THE MARYLAND-NATIONAL CAPITAL PARK AND PLANNING COMMISSION  
Montgomery County Department of Park and Planning

**MEMORANDUM**

SUBJECT: Preliminary Plan No. 1-05001  
Fairland View  
Stravinsky Drive/Fairland Road  
Fairland/White Oak Policy Area

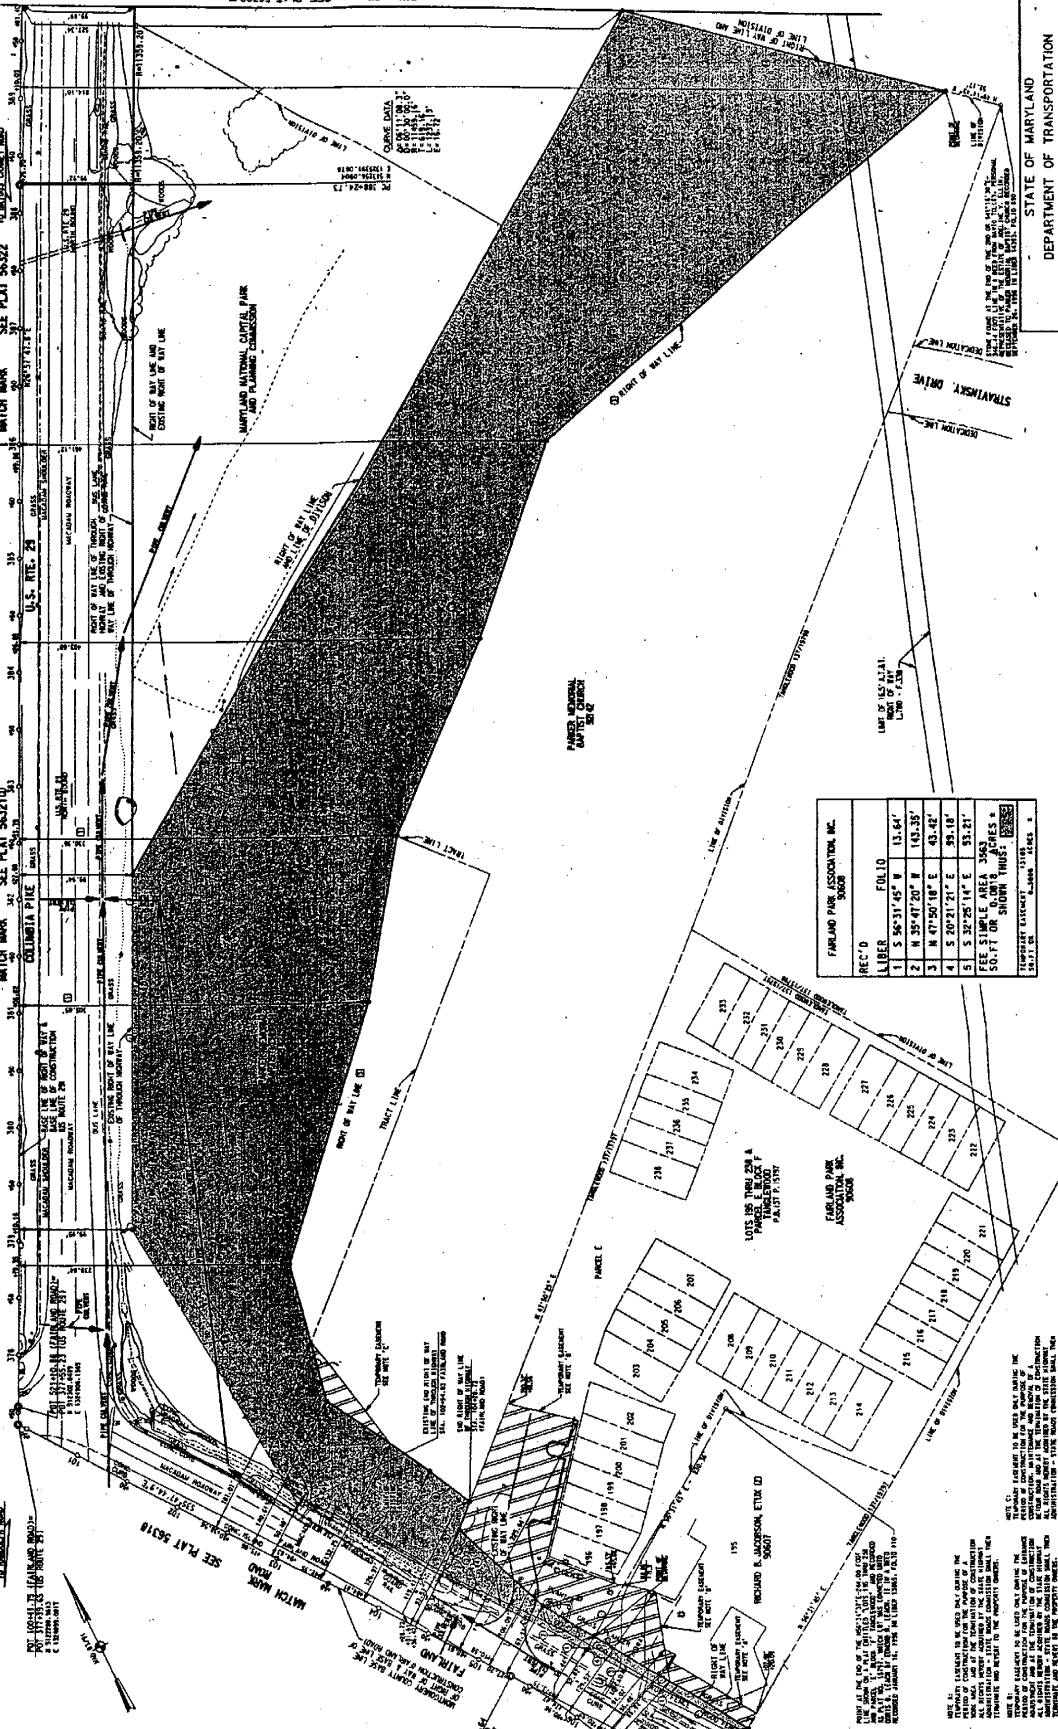
1. Place in reservation the area shown on Attachment 1, dated March 17, 2004 ("Reservation Area") until the earlier of (a) September 1, 2005; or (b) a final Record of Decision is issued by the FHWA, and that Record of Decision does not include the Reservation Area, or any portions thereof, within the final Intercounty Connector (ICC) alignment.

2. If FHWA issues a final Record of Decision that includes the Reservation Area, the applicant shall submit a revised Preliminary Plan that locates all dwelling units and related infrastructure (e.g., roads, public areas, etc.) outside of the Reservation Area.

The ICC planning process has concurrence on two alternative alignments, selected through the Alternatives Retained for Detailed Study (ARDS) process, called Corridor 1 and Corridor 2. Corridor 1 is the southern alignment that generally follows the alignment incorporated in the area master plans for the ICC, and Corridor 2 is the alignment to the north that is not represented in any area master plans. Of the above two alternative roadway alignments, based on the most current information provided by the SHA, the proposed Corridor 1 alignment interchange with Columbia Pike (US 29) would physically impact the proposed Fairland View development as shown on Attachment 1.
